Monticello Nuclear Generating Plant
Docket 50-263
Renewed Facility Operating License No. DPR-22

Response to November 14, 2008, Request for Additional Information for License Amendment Request: Revision to the Allowable Value and Channel Calibration Surveillance Interval for the Recirculation Riser Differential Pressure – High Function (TAC No. MD6864)

GEH Responses to Monticello Third Round RAIs 1 through 3

Monticello LPCI Loop Select Logic Detectable Break Analysis – Third Round RAI Response, RAI 1 through 3

Figure 1: Simplified Recirculation Loop

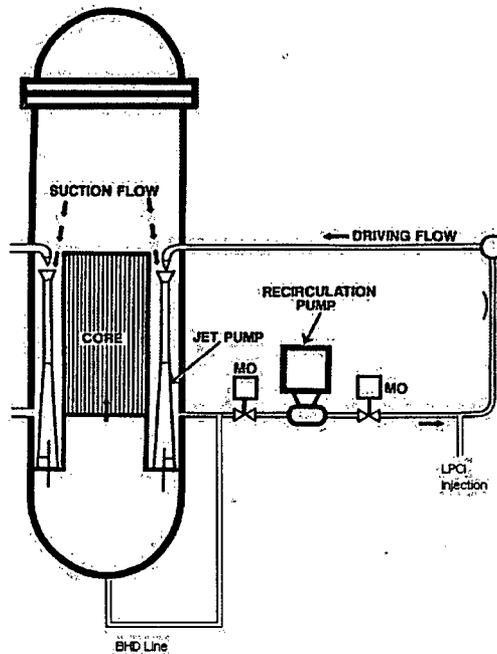
3) Regarding RAI4 on potential ECCS flow lost through recirc discharge line break

Please point to the specific location in NEDE-23785-1-PA supporting the assertion being made for the small break scenarios in question at MNGP. The BWR/4 ECCS system modeled in NEDE-23785-1-PA differs from that of MNGP. NEDE-23785-1-PA does not provide a comparison of small break in discharge line vs. suction line.

The nominal small break results provided in GENE-0000-0052-3113-P-R0 identify the discharge line as the limiting break. Please resolve this apparent contradiction.

An additional consideration in the small break event is not just the lost LPCI flow, which injects into the discharge side of the recirculation line, but also the bottom head drain (BHD) line, which connects from the vessel into the suction side of the recirculation line (see Figure 1). [[
